FISHERS CANYON CREEK CHANNEL IMPROVEMENT PLANS

FISHERS CANYON APARTMENTS IS A MULTI-FAMILY RESIDENTIAL DEVELOPMENT THAT PROPOSES 336 DWELLING UNITS ALONG THE FISHERS CANYON CREEK CORRIDOR. THE PROJECT EMBRACES FISHERS CANYON CREEK TRIBUTARY TO THE WEST AND FISHERS CANYON CREEK TO THE NORTH WITH CREEK IMPROVEMENTS. COUNTY PROJECT NUMBER #CDR246.

FISHERS CANYON CREEK
CHANNEL IMPROVEMENT PLANS
EL PASO COUNTY, COLORADO
COVER

FISHERS CANYON CREEK
GRADING AND EROSION CONTROL PLANS
EL PASO COUNTY, COLORADO
FINAL GEC PLAN

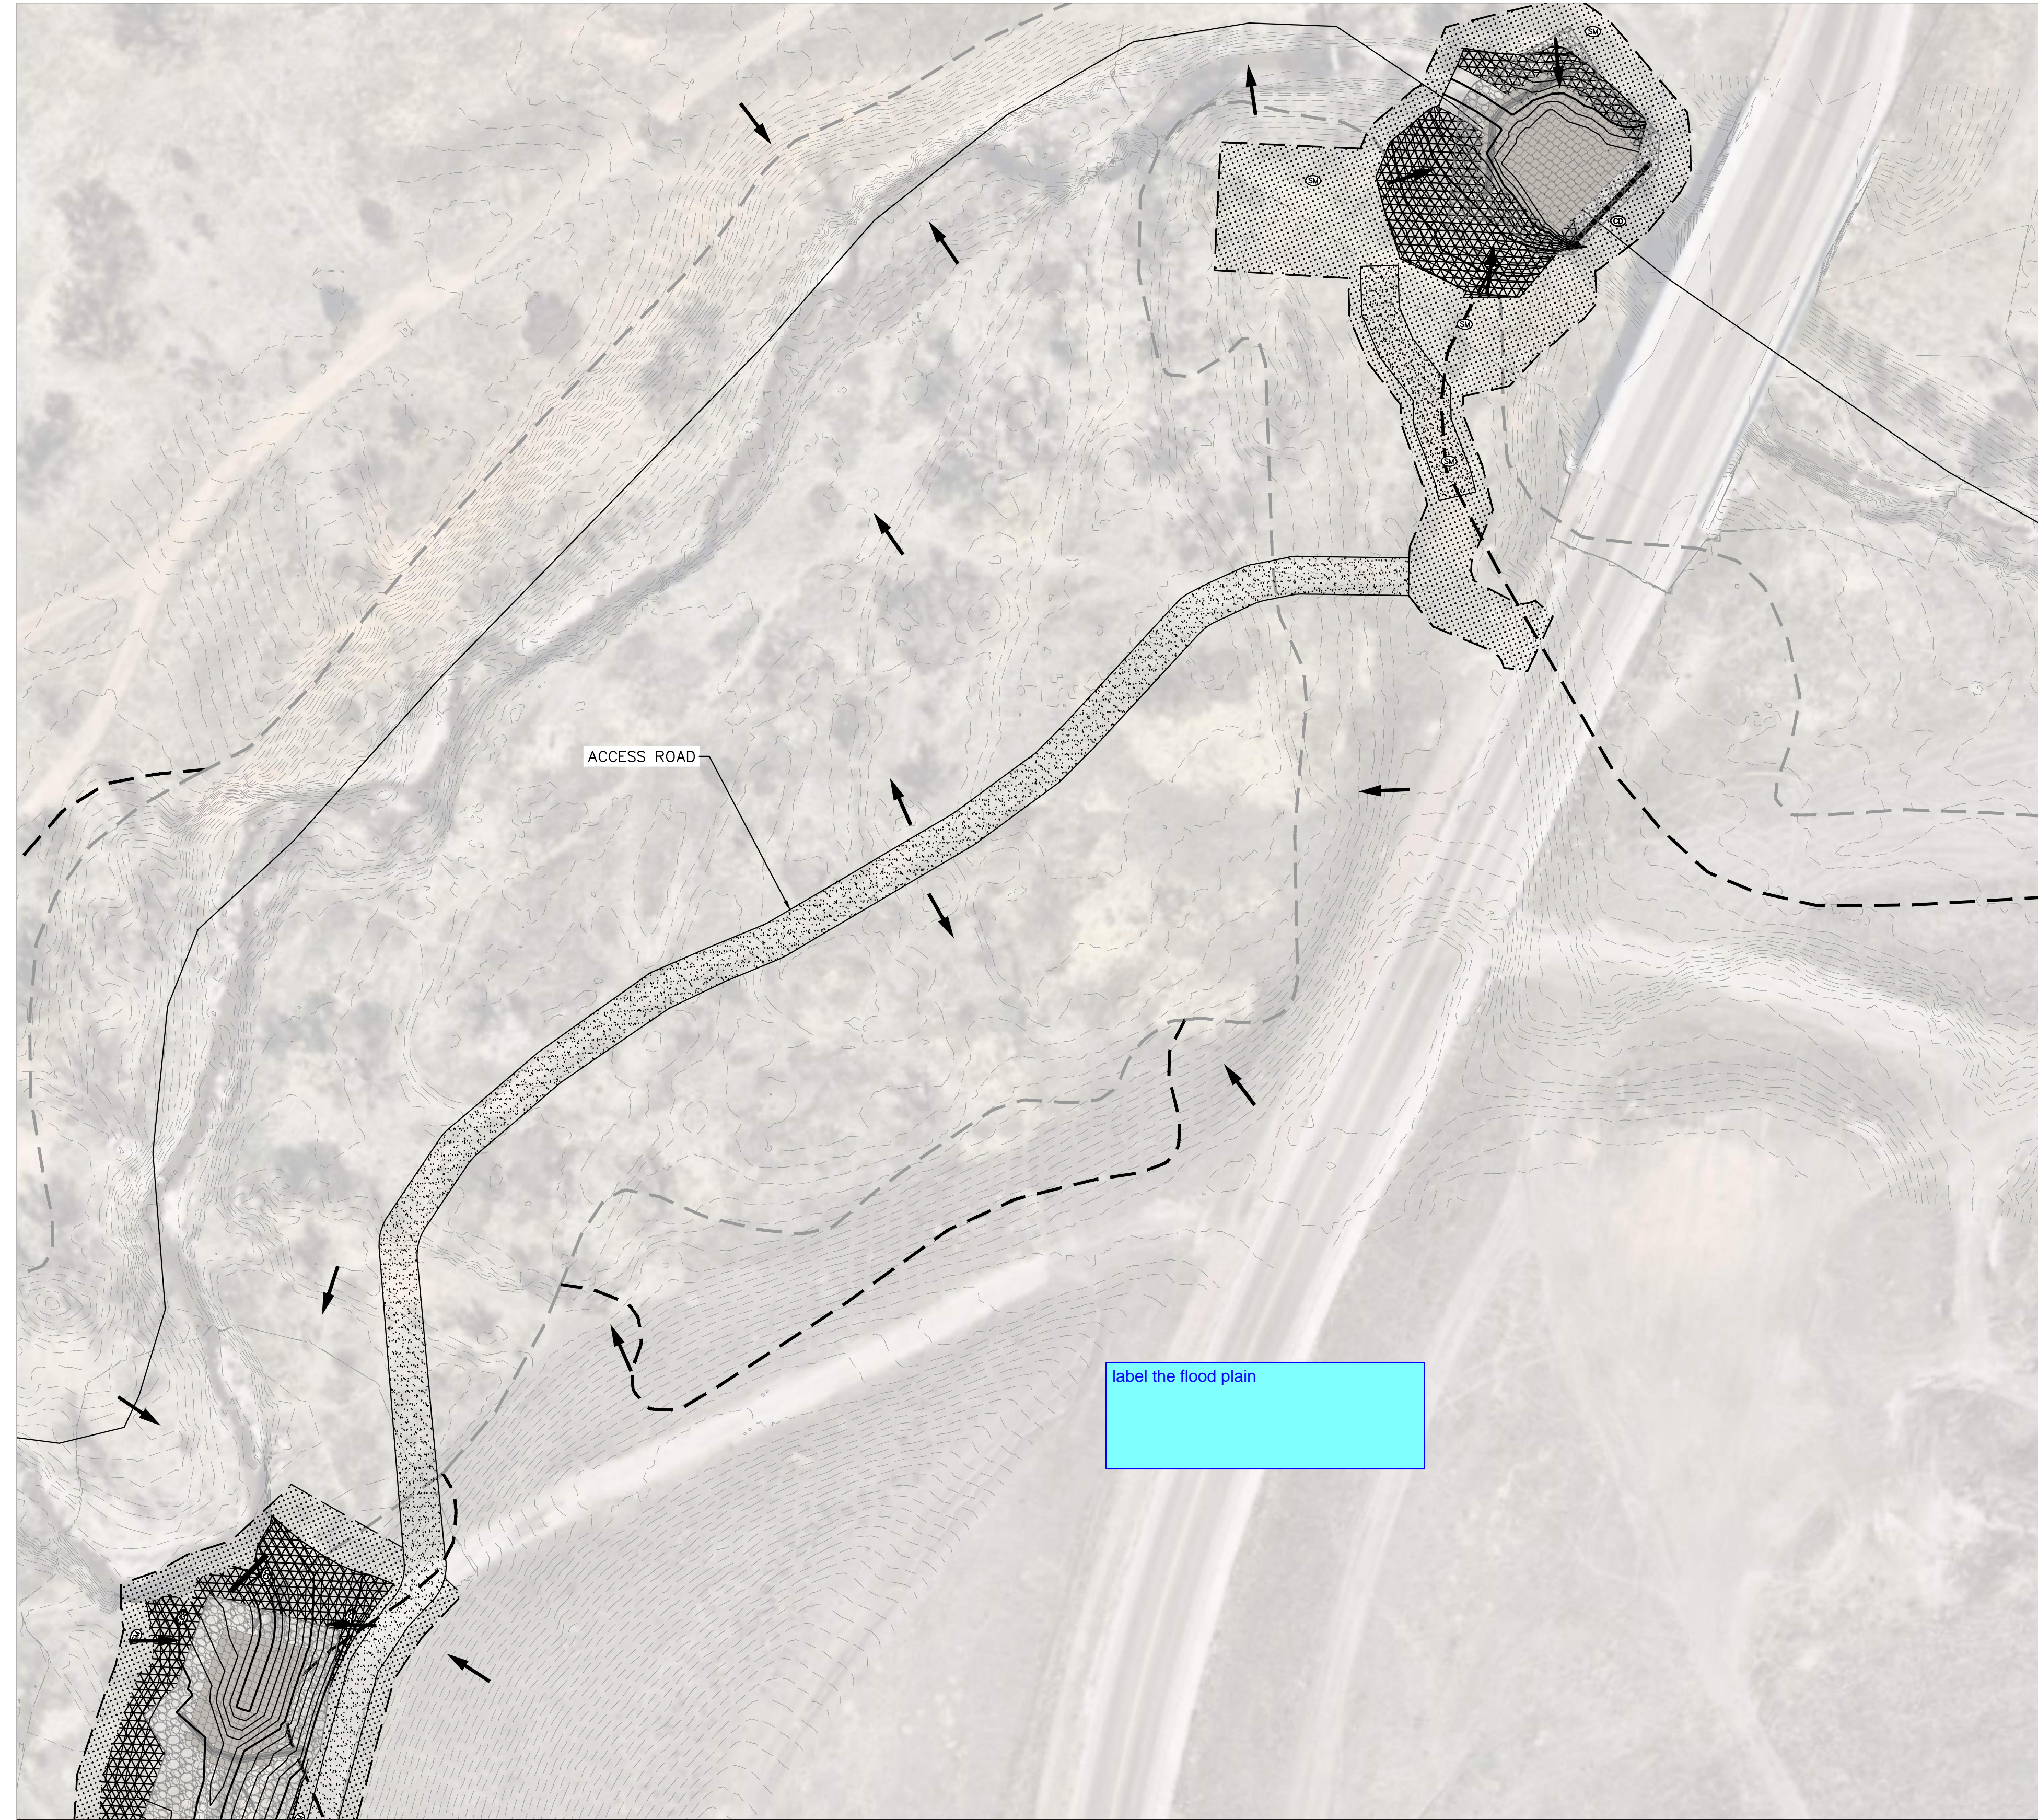
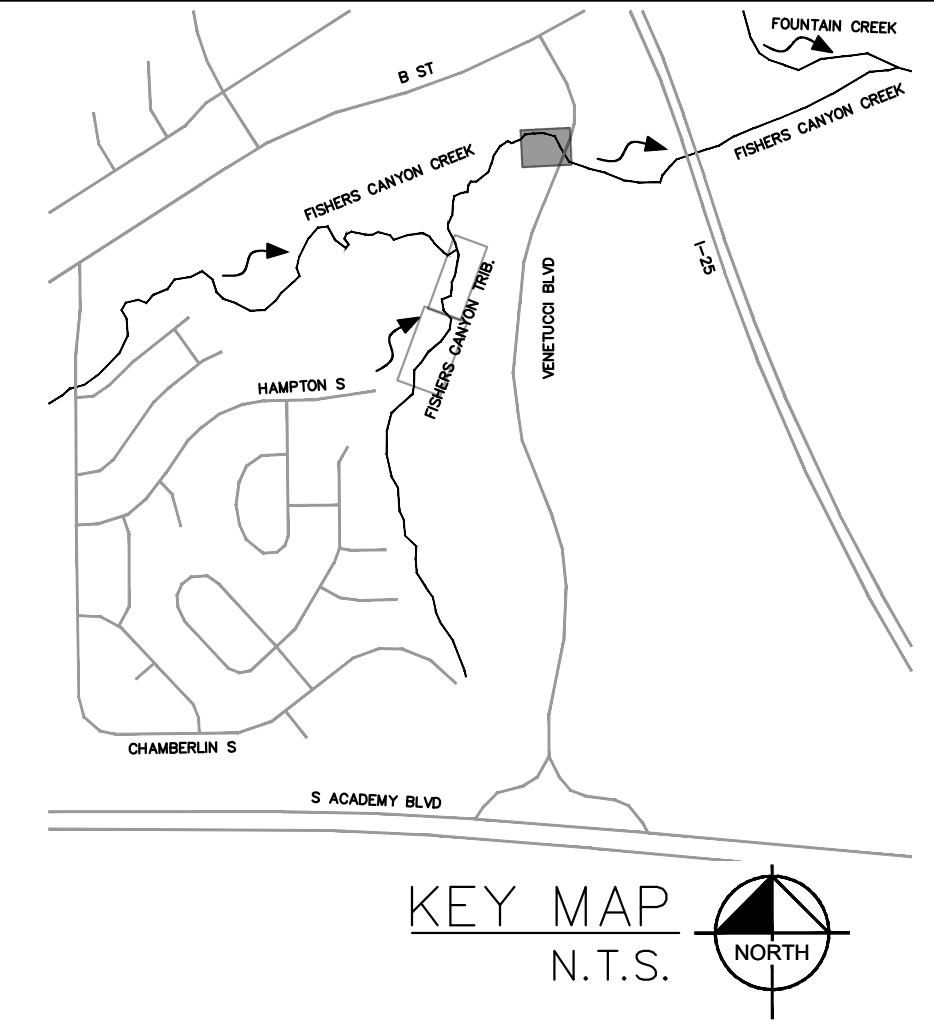
label the flood plain

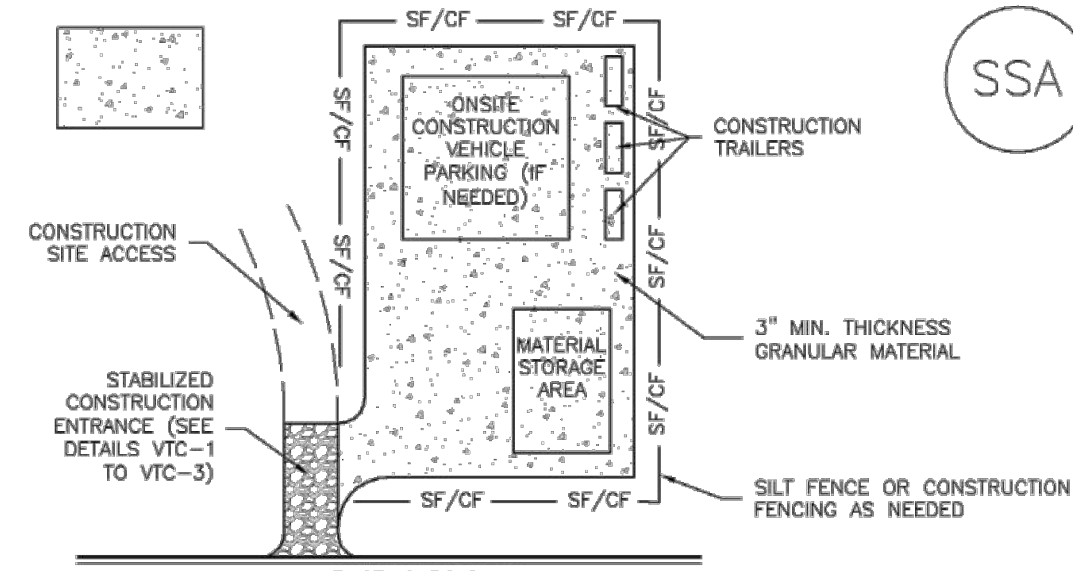
Verify which detail is to be used. If less than 75' long, Stormwater needs to verify.
